TECHNICAL BULLETIN

Products: [Vanguard® Medium FTS 370d LED Tower Lighting System](#)
[Vanguard High FTS 270 Obstruction Light](#)
[Vanguard Red FTS 371 SMART with SNMP](#)
[FTM 190 SNMP Monitoring](#)

Purpose: Flash Technology is issuing this technical bulletin to notify customers, sales, technical support and service teams that the LTE Ethernet modems we offered have been discontinued by the manufacturer with a drop-in replacement.

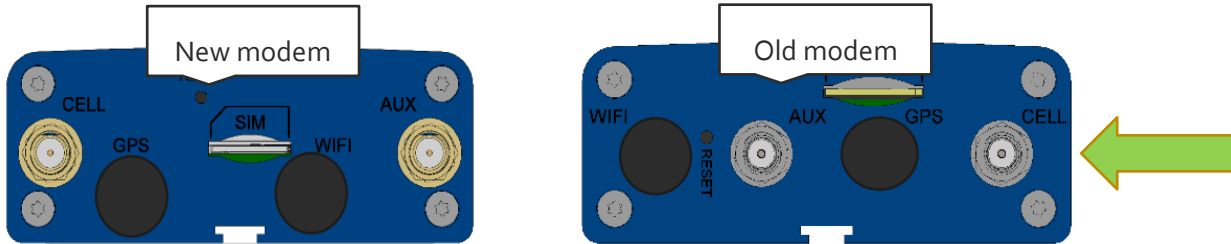
SIM Card type: The new modem will use a 3FF SIM card instead of a 2FF as the previous models.

CELL connector location: The new modem will have the CELL antenna connector on the left instead of the right as with the previous models
